(6) in WSD 3321/2025 T/J(1296/2025)

**Approval of "GEBERIT" Flush Valve
(General Acceptance No. ZC20260237F)**

Details of Fitting: 2" Plastic dual flush valve

Model: 223.022.21.1W

223.022.21.1W

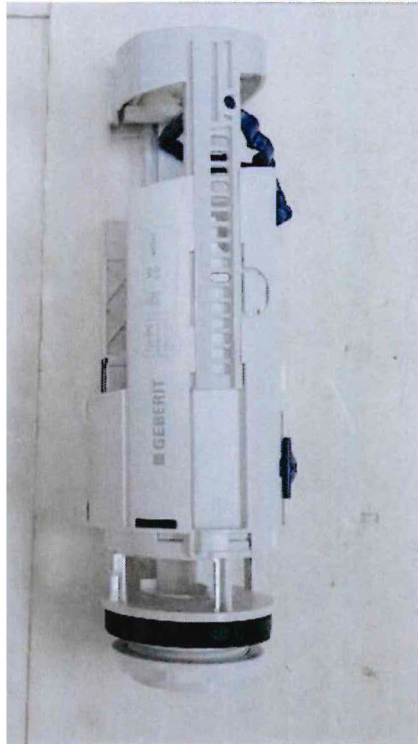
As the fitting has not been tested for use in contact with water intended for human consumption, the fitting can only be used in flushing water plumbing system.

"The flushing volume of the flushing valve should be adjusted to suit the design of the toilet bowl so that wastes can be cleared effectively by a single flush."

"The fitting should be used within the range of working pressures specified by the manufacturer." AND

"The installed fitting should not result in backflow of water that will contaminate the flushing water supply."
